## **ADDENDUM NO. 1**

**PROJECT NAME: *Grand Ridge Fire Station***

**PROJECT NUMBER: *FLORIDA COMMERCE: CDBG MT147***  
***DHM PROJECT NUMBER: GRD22MT***

**GRAND RIDGE FIRE DEPARTMENT  
ARCHITECTURAL ADDENDUM  
November 12, 2025**

**A-5.0**

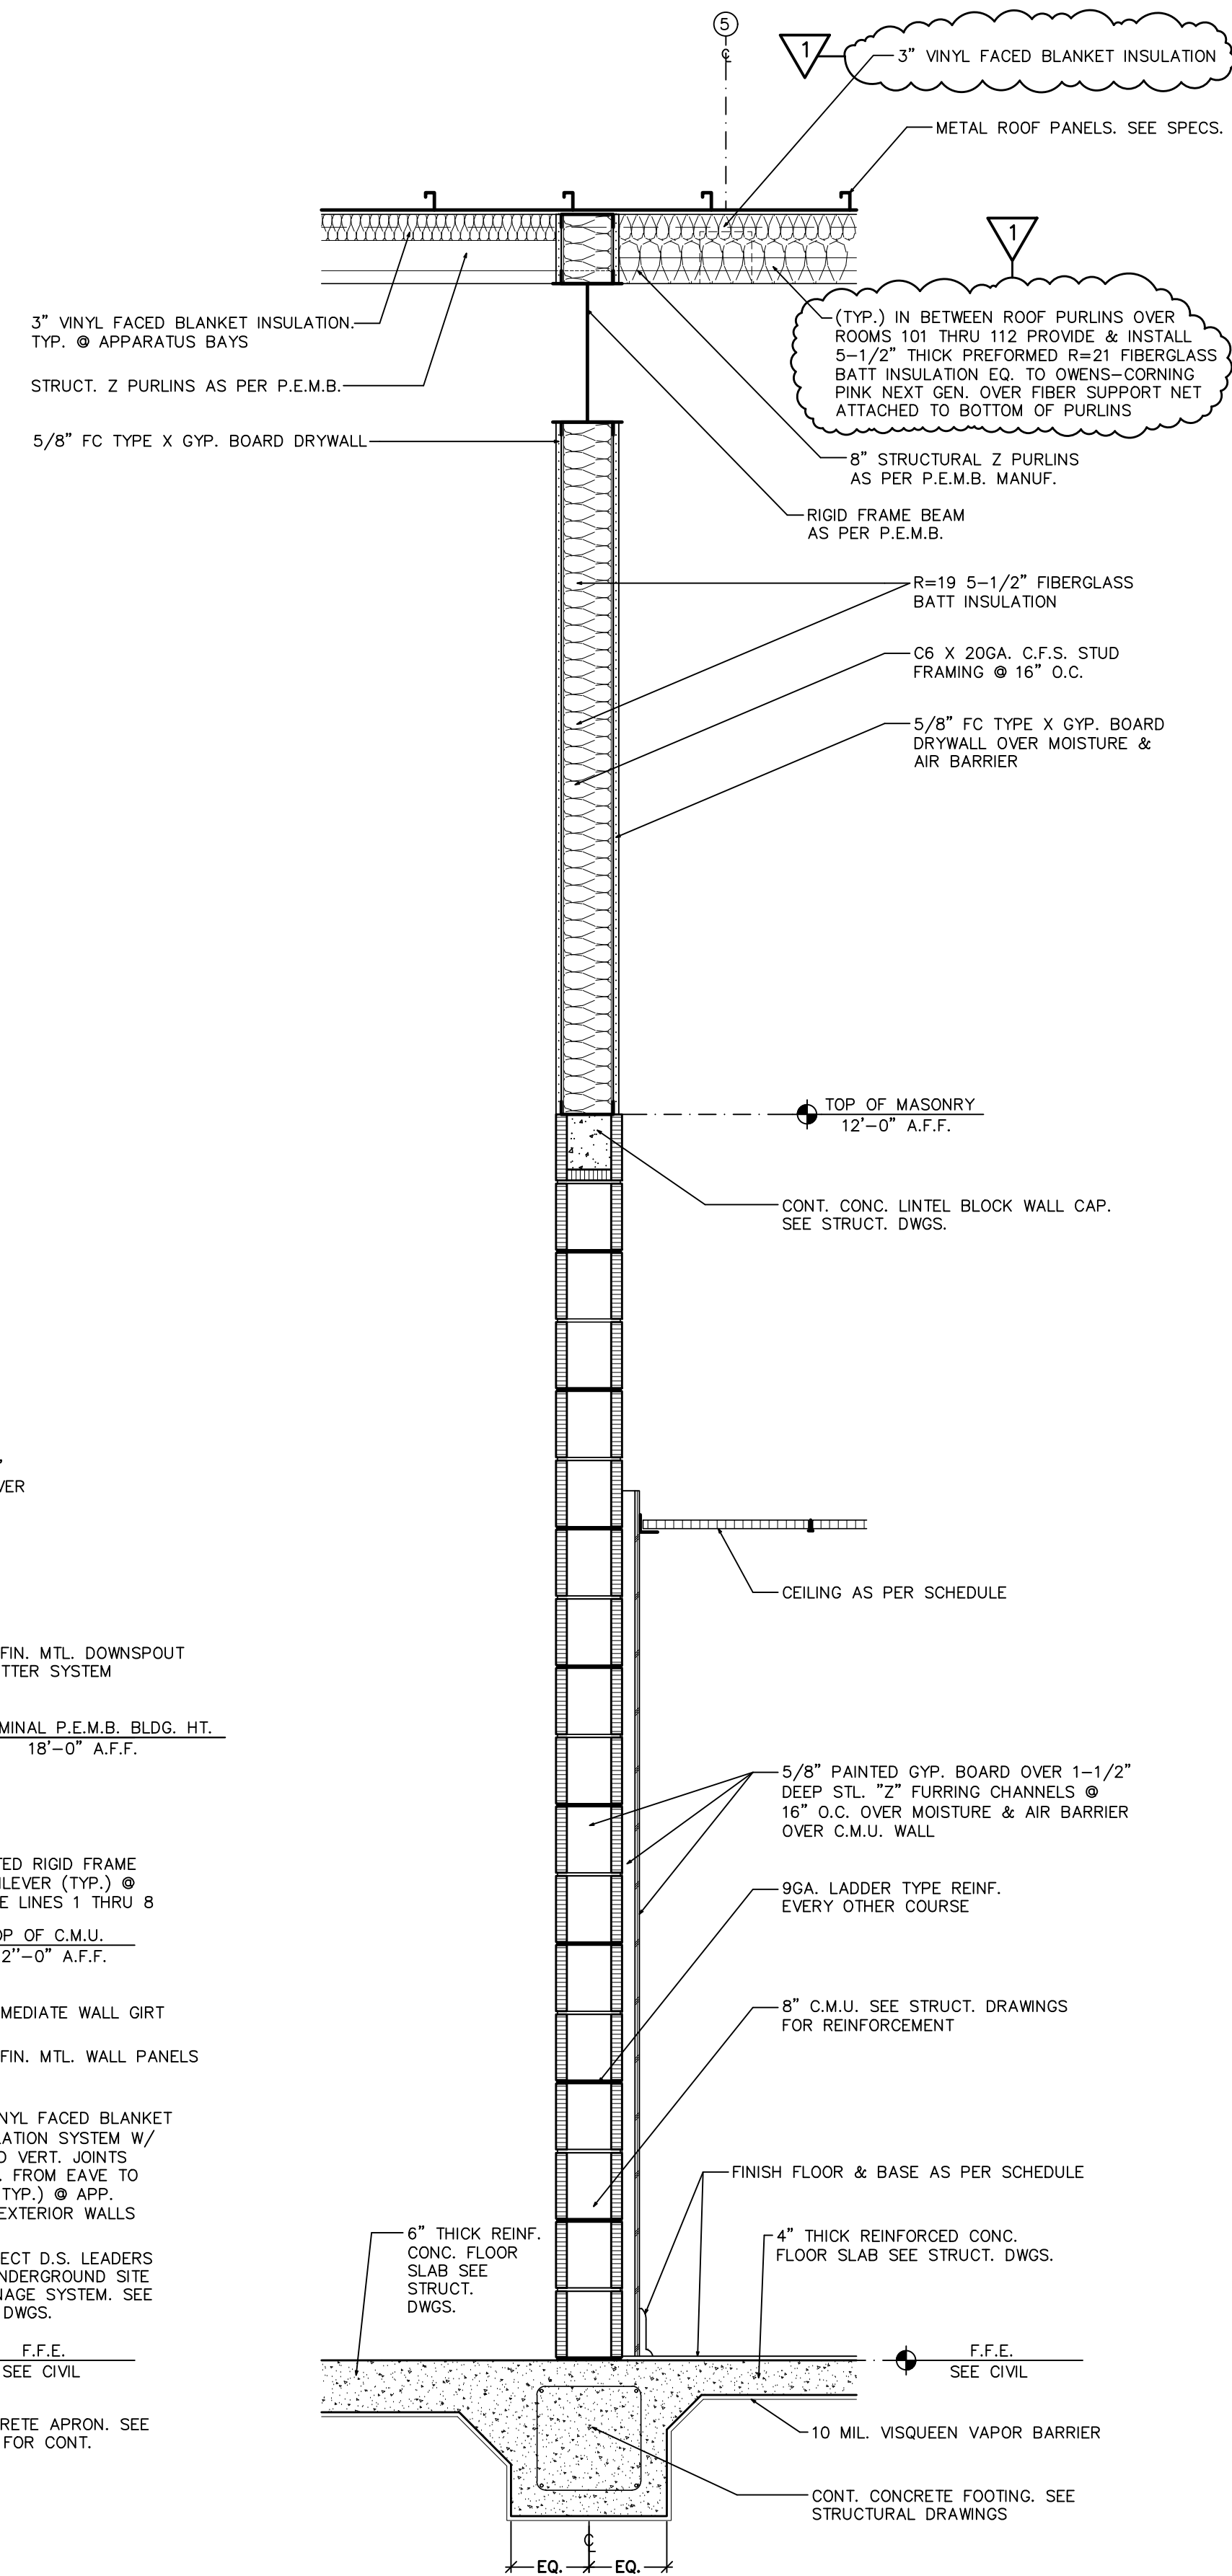
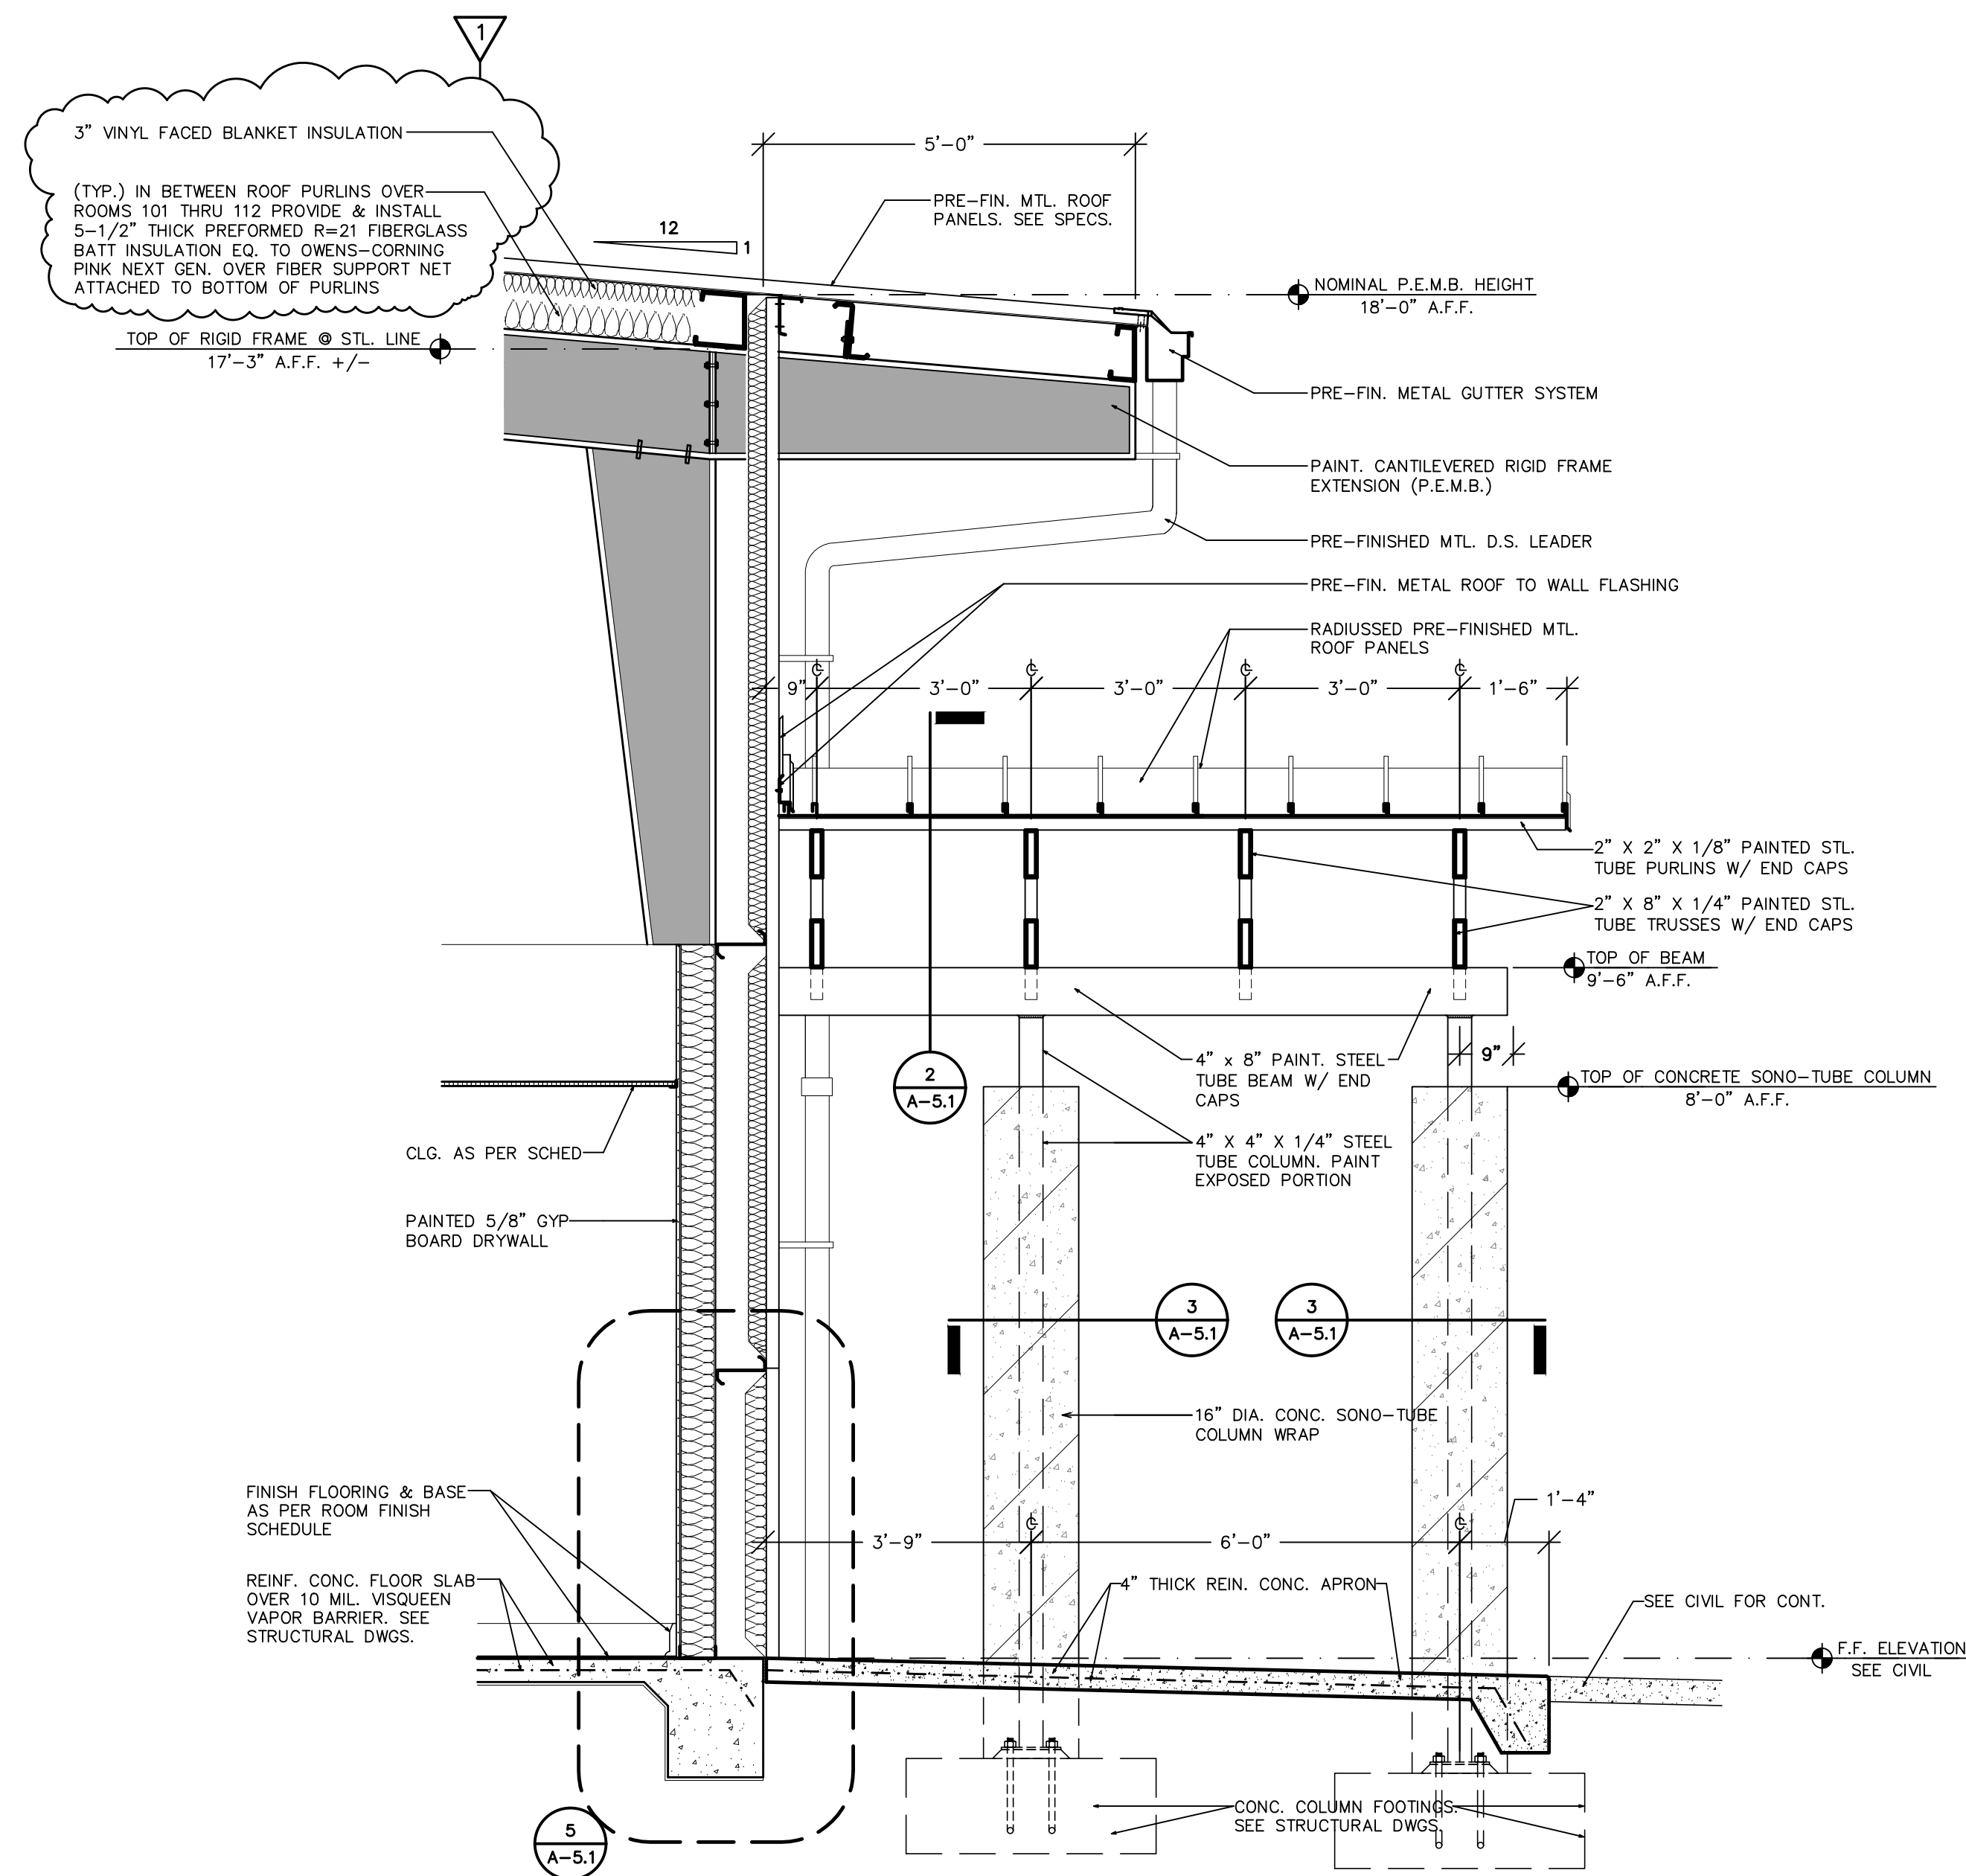
| <b>Item 4:</b><br>11-12-2025 | <b>Drawings, Sheet A-5.0, Transverse Building Section 1/A-5.0,</b><br><br><b>Refer to Call Out That Reads</b> - 24-gauge metal roof panels.<br><br><b>Change to Read:</b> Metal roof panels as per specifications.                                                                            |
| <b>Item 5:</b><br>11-12-2025 | <b>Drawings, Sheet A-5.0, Transverse Building Section 1/A-5.0, See Revised Sheet A-5.0, included with this addendum</b><br><br><b>Addition</b> of column wrap detail 3/A-5.0 detailing column wrap condition at interface of masonry wall at column line 6 and rigid frame columns 6A and 6D. |
| <b>Item 6:</b><br>11-12-2025 | <b>Drawings, Sheet A-5.0 and A-5.1, Transverse Building Section 1/A-5.0 and Section 1/A-5.1, See Revised Sheets A-5.0 and A-5.1, included with this addendum</b><br><br><b>Revision</b> – Required roof insulation assembly over rooms 101 and 112.                                           |
